# WATER QUALITY MEMORANDUM

Utah Coal Regulatory Program

TO: Internal File  
THRU: James D. Smith, Permit Supervisor *DS 7 Dec 2010*  
FROM: Steve Christensen, Environmental Scientist *SKC*  
RE: 2010 2<sup>nd</sup> Quarter Water Monitoring, Canyon Fuel Company (CFC), LLC, Dugout Mine, C/007/0039-WQ10-2, Task ID #3560

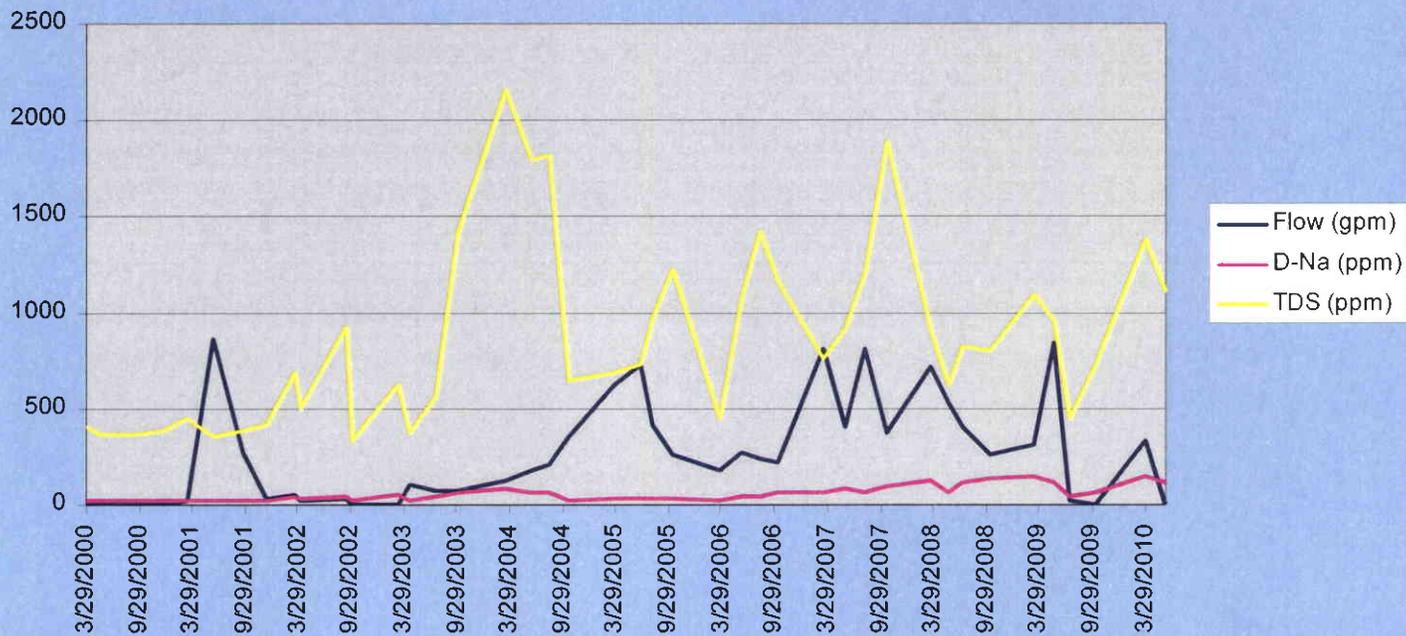
Stream monitoring site DC-1 had reported elevated dissolved sodium (D-Na), chloride (Cl) and bicarbonate (Bcrb) the previous quarter. However; all of the previously elevated concentrations were back to within two standard deviations of the data set this quarter. Continued monitoring will be conducted at monitoring site DC-1 in order to determine if a trend is emerging.

Monitoring site DC-2 reported elevated dissolved potassium (D-K), dissolved calcium (D-Ca), dissolved magnesium (D-Mg), dissolved sodium (D-Na), Cl, sulfate (SO4) and total dissolved solids (TDS). Site DC-2 was inaccessible during the 1<sup>st</sup> quarter of 2010. However; elevated concentrations of D-K, D-Na, Cl and TDS were reported during the 4<sup>th</sup> quarter of 2009. Continued monitoring of these parameters will be conducted in order to determine if a trend is developing.

The FAN monitoring site below the Pace Canyon Fan portal reported elevated levels of D-Na, CL SO4 and total alkalinity during the 3<sup>rd</sup> and 4<sup>th</sup> quarters of 2009. The site was inaccessible due to snow conditions the first quarter of 2010. An elevated D-Na concentration was reported this quarter.

Site PC-2 began developing an upward trend in TDS and its components. The previous four quarters had shown an upward trend in TDS and its components. However; all reported concentrations for PC-2 returned to within two standard deviations from the mean this quarter. The water quality standard for Pace Creek (as established by the Division of Water Quality) is 3,000 mg/L. The reported TDS value for PC-2 this quarter is 580 mg/L.

Continued monitoring of stream monitoring sites DC-1, DC-2, FAN and PC-2 for upward trends in TDS and its chemical constituents.
